CONTRACT ID NO. 101338

ADDENDUM # 2

Pike County, APD 80-6 (27) Subject:

(1) Revised - Plan Sheets - R2a, R2c, R2e, R2f, R5, R8, R13, R14, R18a, R27,

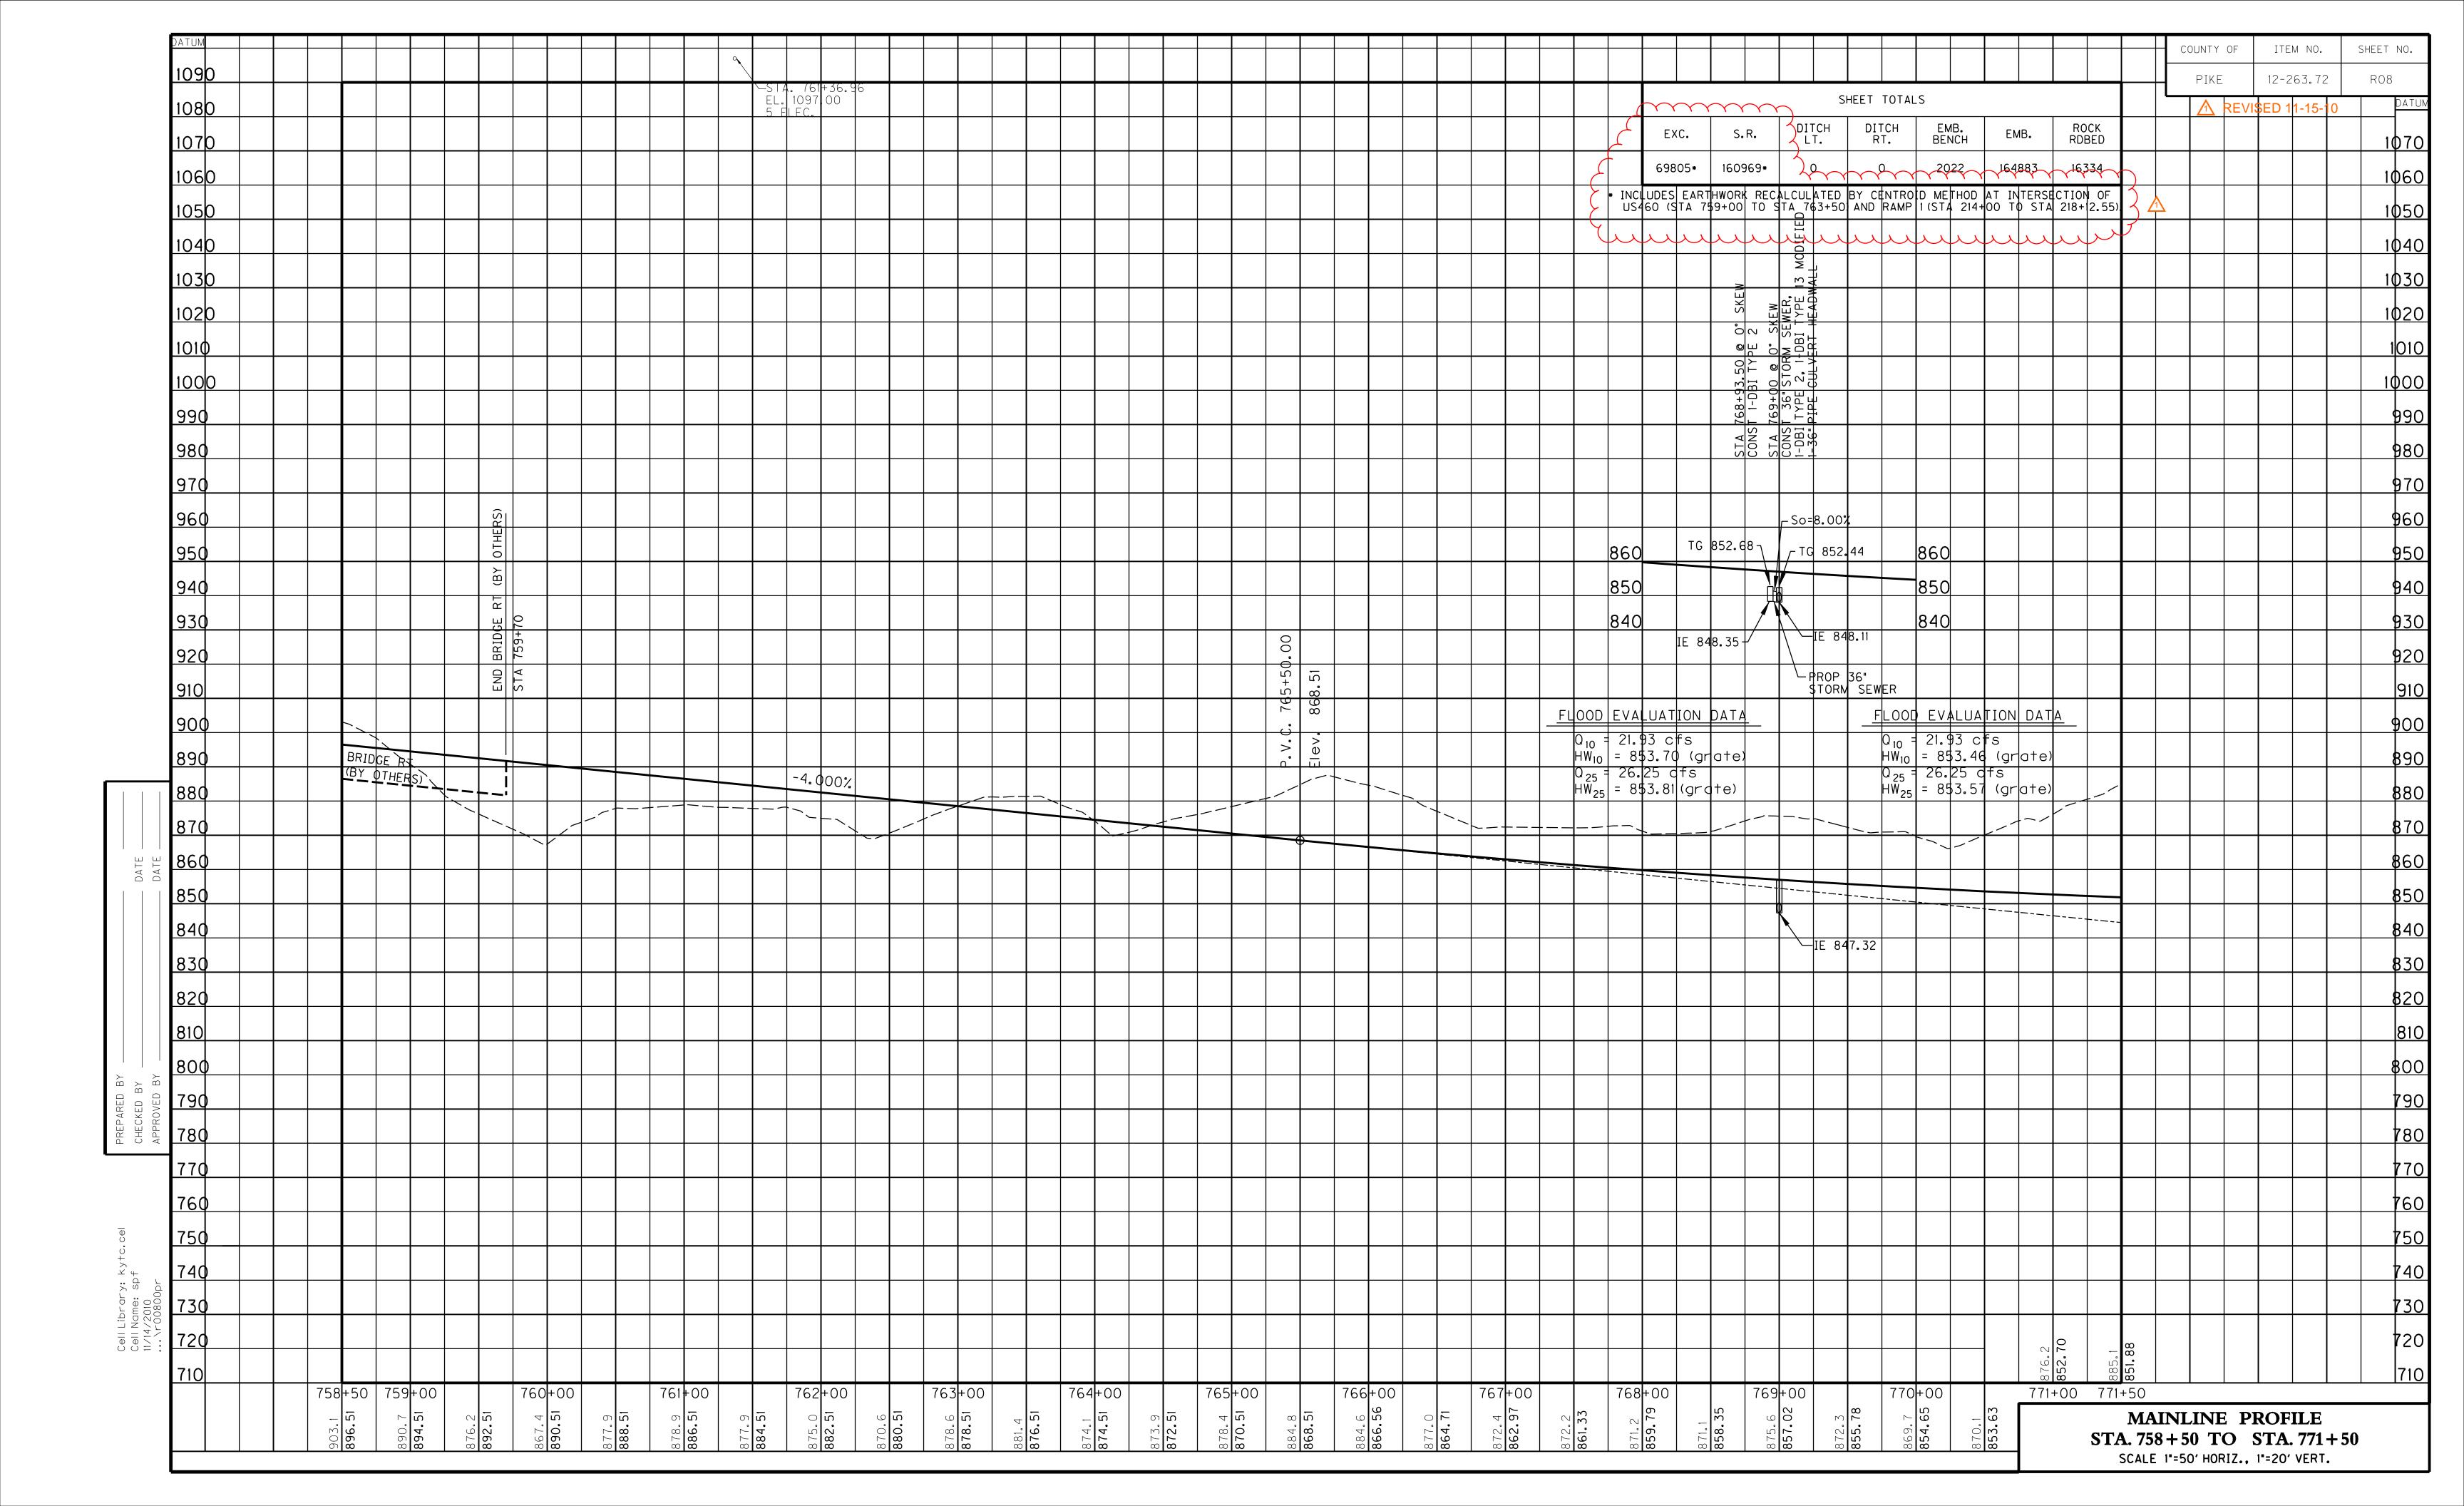
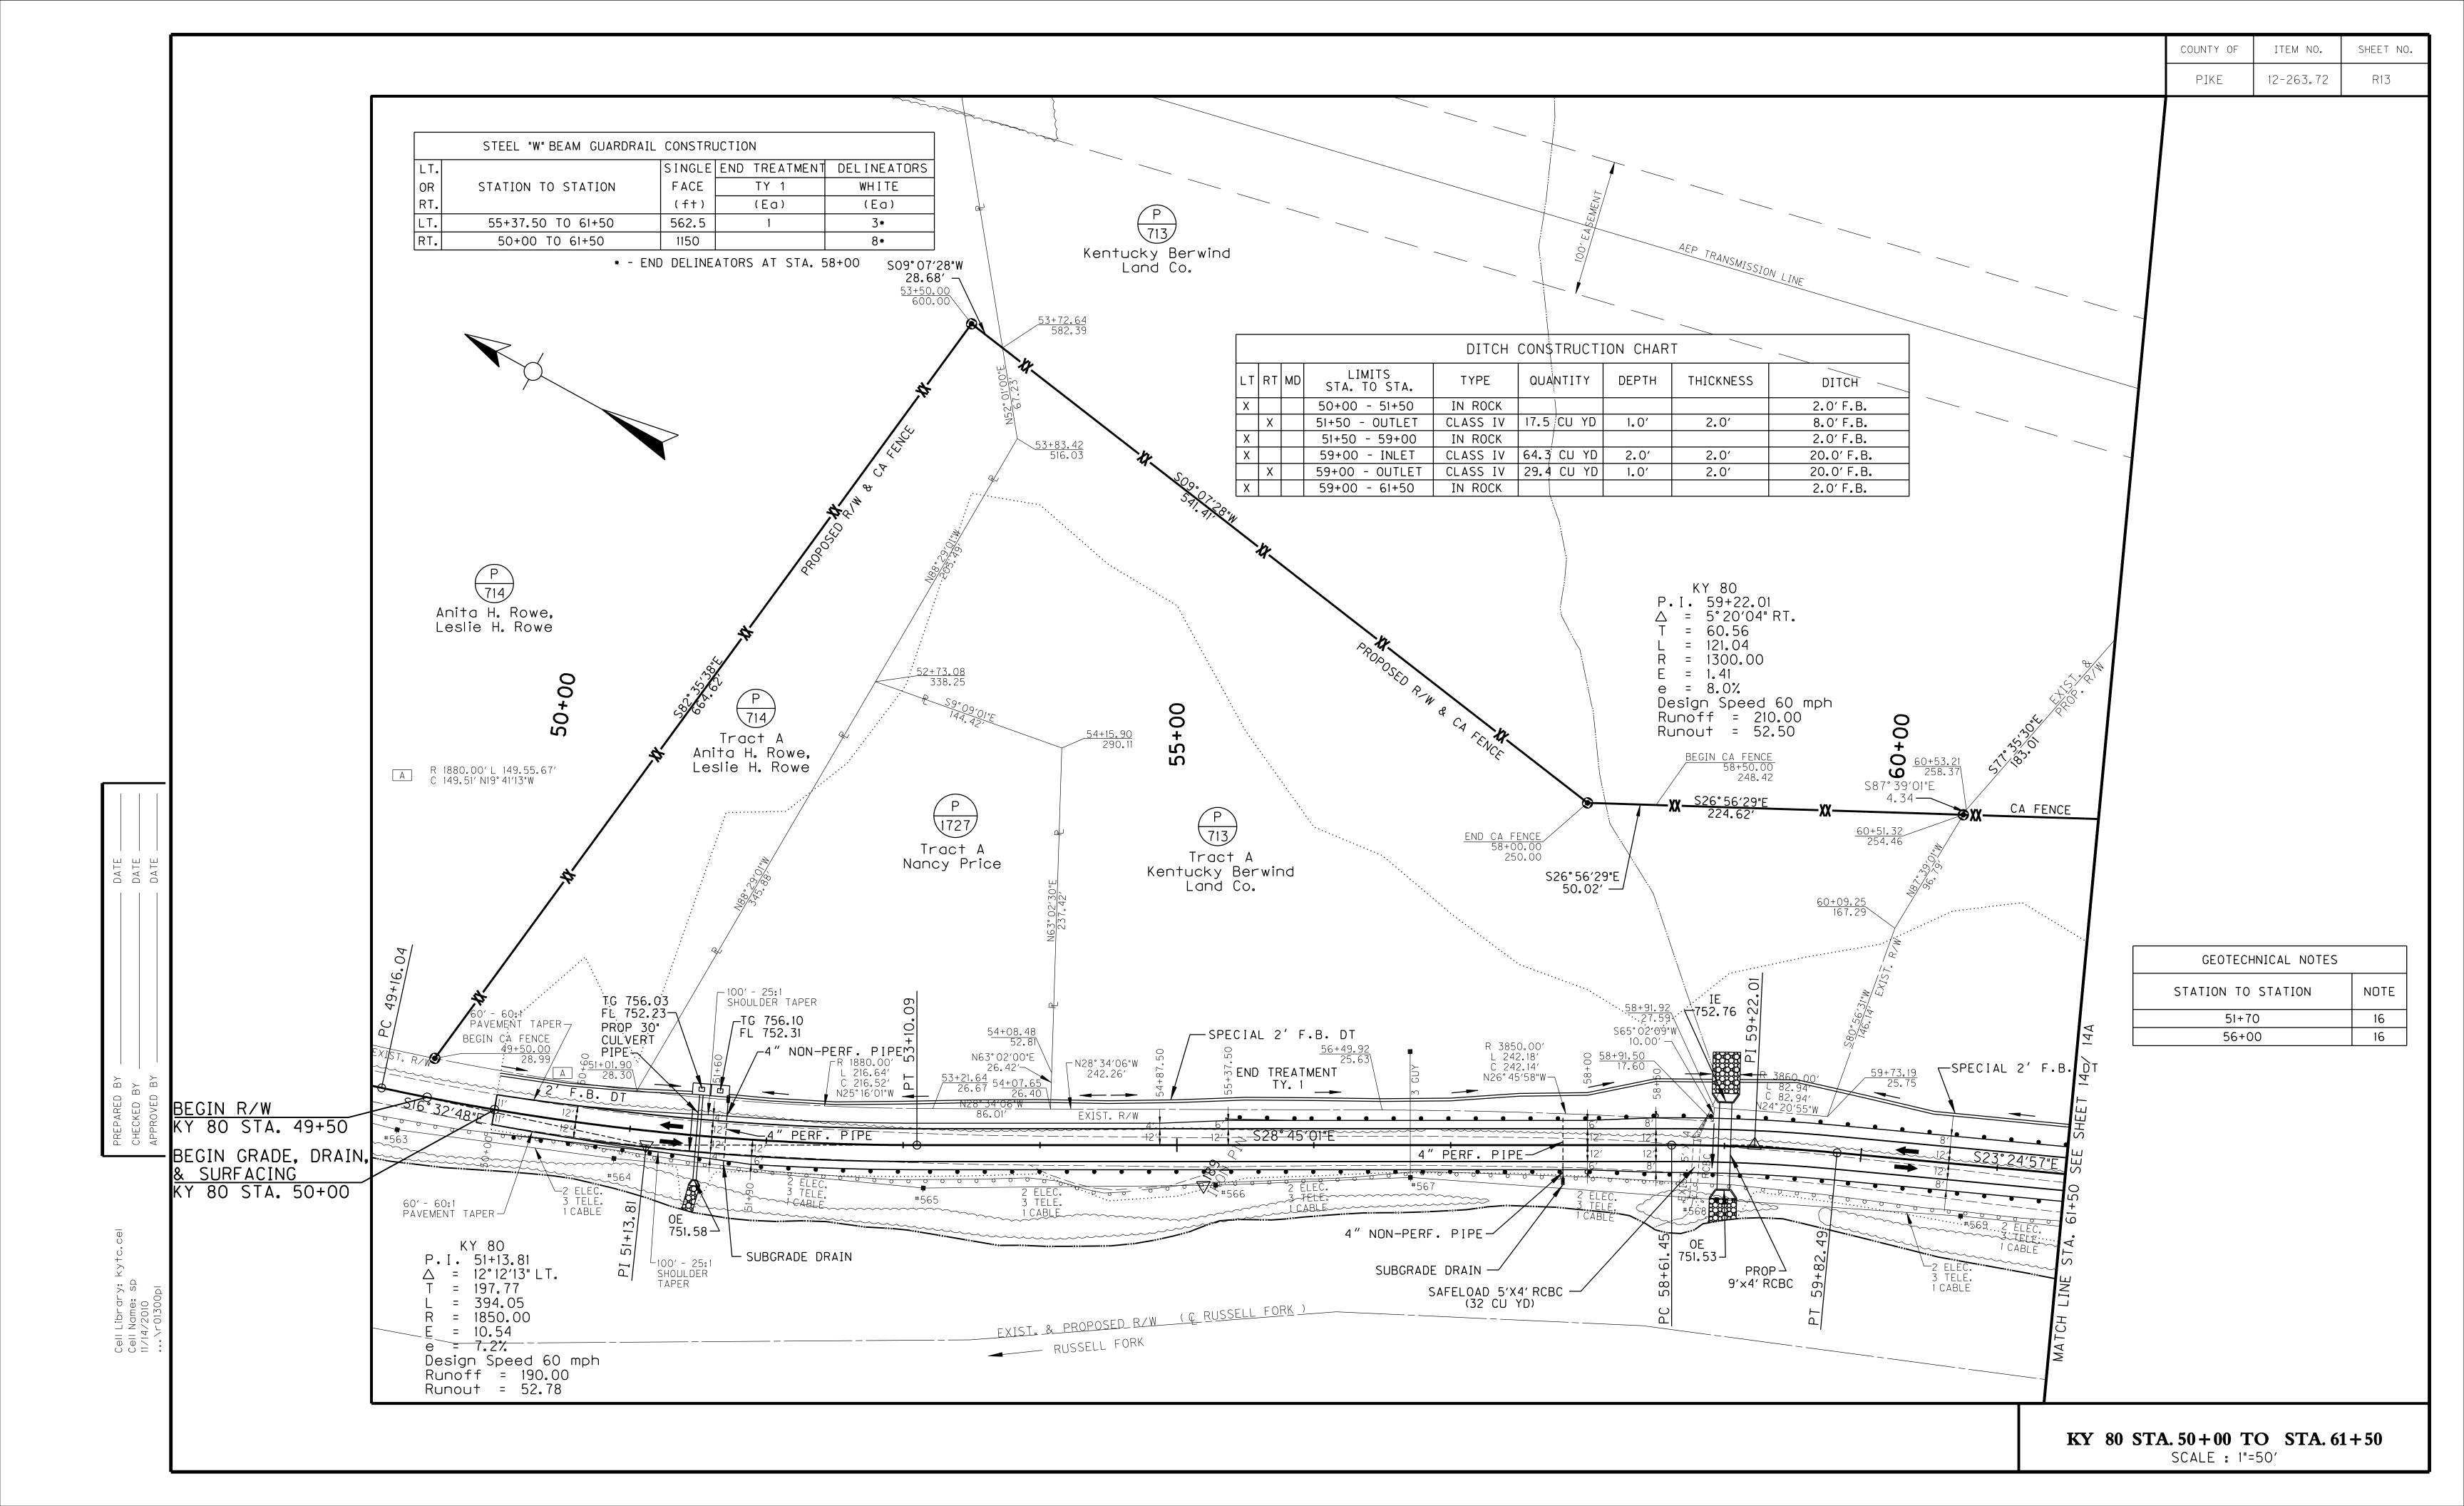
- 8 THE QUANTITY OF ASPHALT SURFACE HAS BEEN CALCULATED BASED ON THREE COARSES BEING REQUIRED DURING THE DURATION OF THE PROJECT.
- 9 THE QUANTITY FOR CRUSHED STONE BASE HAS BEEN DOUBLED FOR APPLICATION TO ROCK ROAD BED.
